## **Brooklyn Industry Meeting – In person**

January 18, 2024

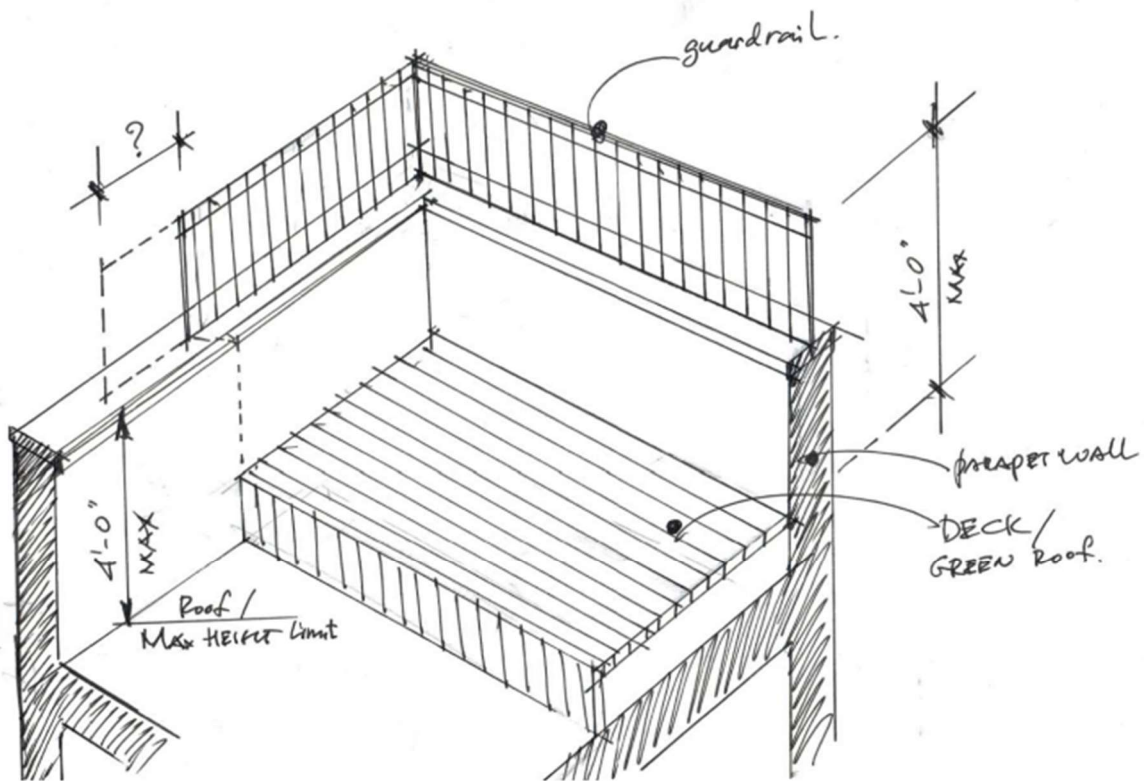
**Q: Which section should be followed for height requirements if proposed fence enclosing open parking areas is located within required front yard. Not clear which section is more restrictive in this context.**

**It depends on how many parking spaces are proposed, and what zoning district. ZR 25-66 is specific to how many parking spaces will trigger screening, and ZR 23-44 does not mention screening requirements under parking spaces for automobiles, off-street, open, accessory, within a front, side or rear yard. Instead, ZR 23-44 speaks of fences in general and not specific to parking.**

**Regarding zoning districts, quality housing buildings will require that all open accessory off-street group parking facilities be screened from dwelling units, adjacent zoning lots and streets in accordance with paragraph (a) of Section 25-66, see ZR 28-41.**
